**From:** Comar, Manny  
**Sent:** Thursday, November 01, 2012 5:04 PM  
**To:** TurkeyCOL Resource  
**Subject:** FW: DRAFT RAI Responses FPL Turkey Point 6 & 7 for eRAI 5896 - Vibratory Ground Motion  
**Attachments:** Draft Revised Response for NRC RAI Letter No. 037 (eRAI 5896) 2.5.2-9.pdf

**NRC RAI Letter No. PTN-RAI-LTR-037**

**SRP Section: 02.05.02 - Vibratory Ground Motion**

**NRC RAI Number: 02.05.02-9 (eRAI 5896)**

Figure 1. Shear Wave ( $V_s$ ) and Compression Wave ( $V_p$ ) Velocity Profiles for Sonic Log 0001

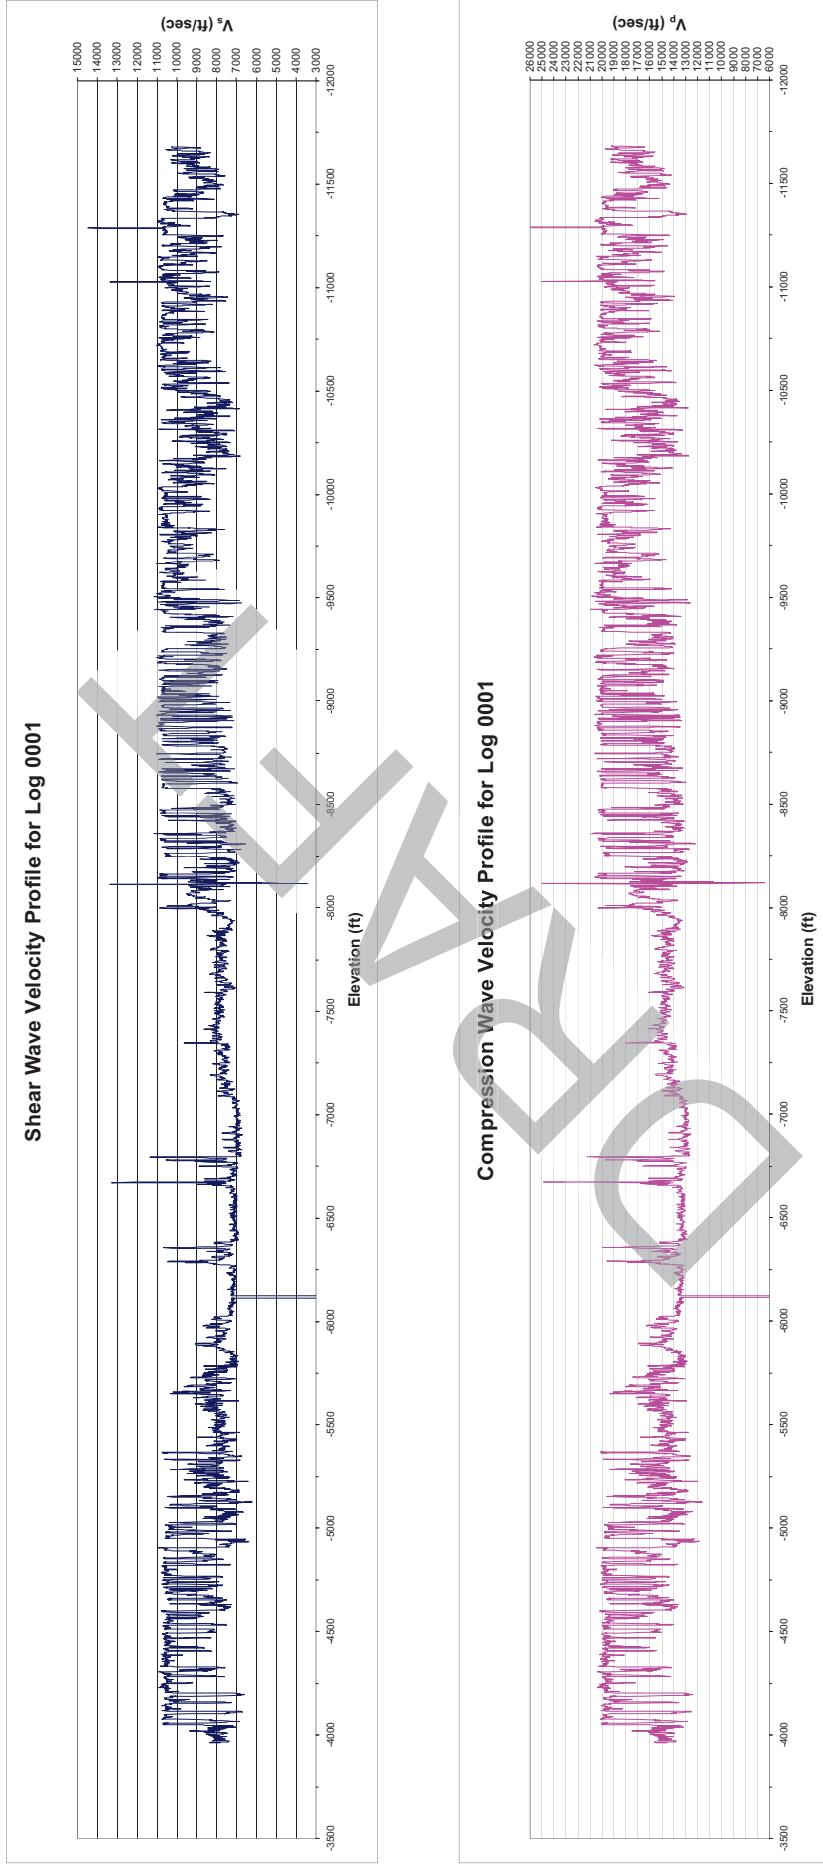
- a. additional information on the applicability of seismic velocity information obtained at such great distances to the Turkey Point site. How was the variation in geology considered in these projections?
- b. individual velocity profiles for each of the eight wells used in estimating the average profile shown in FSAR Figure 2.5.4-211
- c. further details on how larger uncertainties in deeper layers' thicknesses/depths are taken into account in the randomization of the site profile

- b) The compression and shear wave velocity profiles for each of the 8 wells are shown in Figures 1 through 8.
- c) The uncertainties in the dynamic properties of the deeper layers were taken into account by the following two steps.
